CERTAIN 2010 MODEL YEAR TRANSIT CONNECT VEHICLES — HEADLINER PUSHPIN REPLACEMENT

OVERVIEW

FIGURE 1

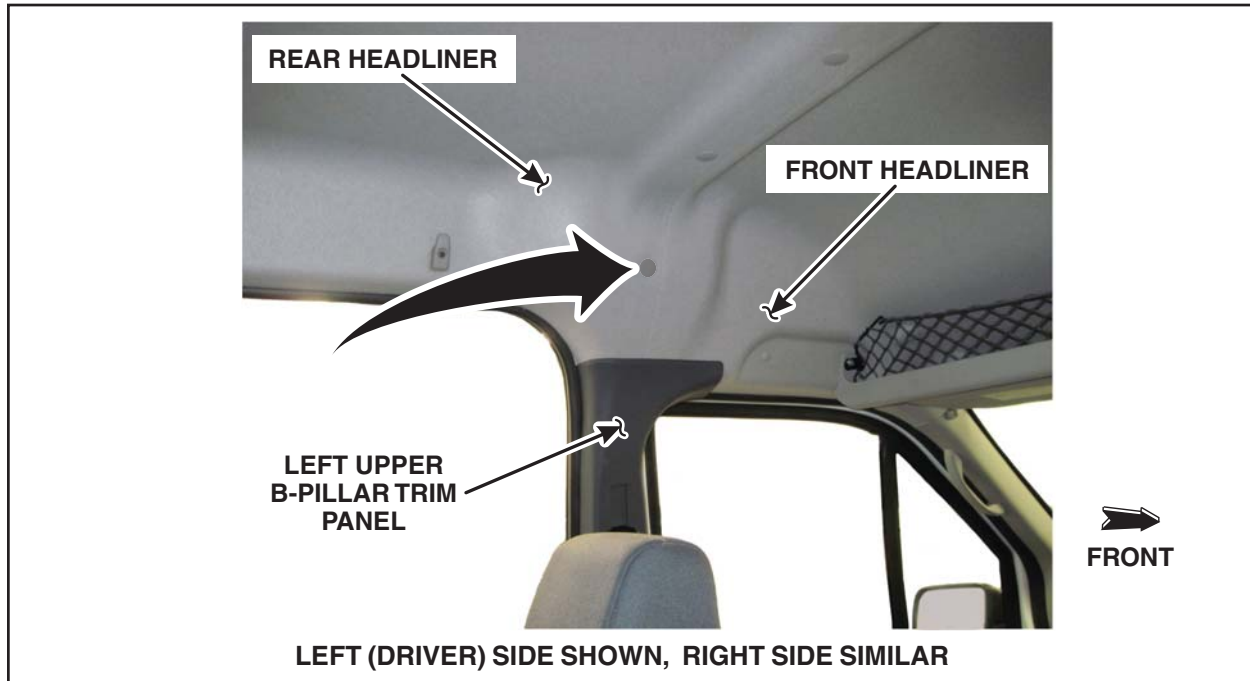
On some of the affected vehicles, the headliner pushpin at the B-pillar may not absorb sufficient energy to conform to the requirements specified by Federal Motor Vehicle Safety Standard (FMVSS) No. 201 - Occupant Protection in Interior Impact.

1. Remove the existing headliner pushpins (one per side) located directly above the right and left upper B-pillar trim panels. See Figure 1.
2. Install the revised pushpins.
